Planning Commission Staff Report

SUBJECT: DR18-186, VAL VISTA & QUEEN CREEK RETAIL

Approve the Finding of Fact and approve DR18-186, Val Vista and Queen Creek Retail: Site plan, landscaping, grading and drainage, elevations, floor plans, lighting, and colors and materials for approximately 2.12 acres, generally located at the southwest corner of Queen Creek Road and Key Biscayne Drive, and zoned Shopping Center (SC) with a Planned Area Development (PAD) overlay.

Attachment 9: Elevations

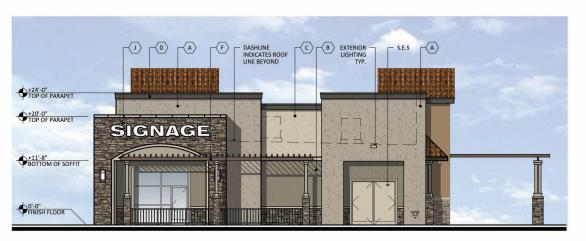
- Commission members asked questions about the aluminum trim on the building. Specifically about its lightness conflicting with the building's darker earth tones.

- o The applicant respectfully chose to retain the dead-end configuration.
- Commission members stated that the proposed color palette should comply with the approved color palette per the Site Design Guidelines.

- The applicant respectfully chose to keep the originally proposed aluminum trim on the building.
- Commission members discussed the proposed drive-through; specifically its length and configuration that exited onto the internal private street

- The color palette has been modified and is now consistent with the approved guidelines.
